272-278 SUMMIT STREET
Legal # 274

APPLICATION FOR PERMIT

AP-272-278 Summit St., corner of Jackson St.

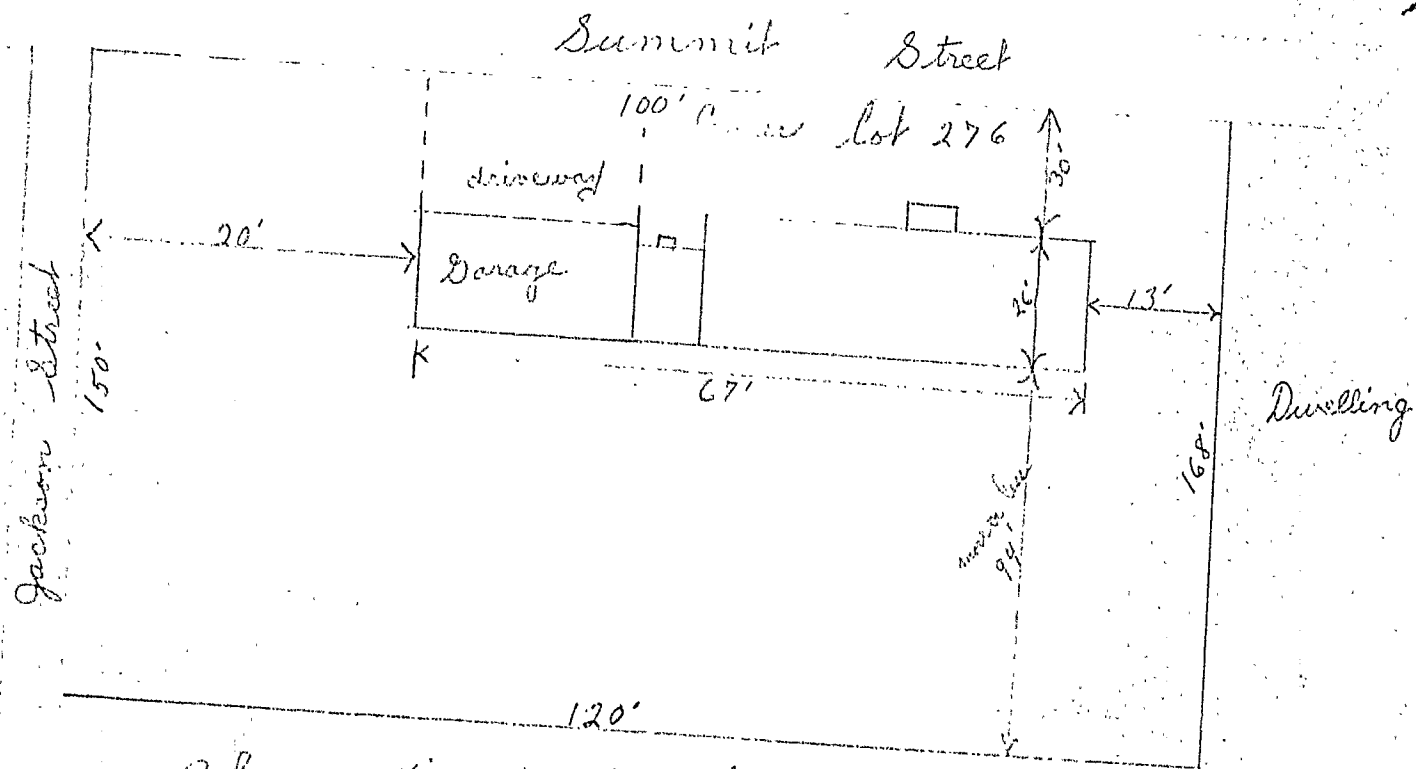
1. Before notification is given for check of forms prior to pouring concrete for foundation walls, the following information is to be furnished:
 - a. With what kind and thickness of fire-resistive material floor of garage is to be surfaced to meet Building Code requirements.

- b. Framing of platforms of porches.
 - c. Size of header over large garage door opening.
 - d. Header over picture window in rear wall.
2. Since the line of Jackson Street does not run at right angles to that of Summit Street, care will need to be taken to make sure that the 20 foot set back on that street is measured to the corner of the building nearest that street line.

4. By acceptance of this permit you agree to provide construction as outlined below unless approval is given for some other type of acceptable construction:

- a. Foundation walls are to extend at least 4 feet below grade at all points.
 - b. The 10 inch thickness of foundation walls is acceptable only at such locations where bottom of wall is to be no more than 6 feet below the finished grade of the ground adjoining it. If height of wall is to exceed 6 feet at any point, an amendment to permit now being issued is to be secured indicating how thick a wall is to be provided at such locations before notification is given for check of forms.

- c. Girder is to be no less than dressed 6x8 Douglas Fir or 8x8 hemlock.
 - d. Bottom member of box sill is to be anchored to the foundation wall at the corners and at intervals of not over 6 feet between corners.

- e. Sills for garage and rear wall of main building are to be no less than 4x6, all one piece in cross section, and anchored to the foundation wall at intervals of not over 6 feet.

- f. Studs in upper half of rear wall are to extend down to the double 2x4 girt on which the floor timbers rest and are not to be supported on a shoe on top of those timbers.
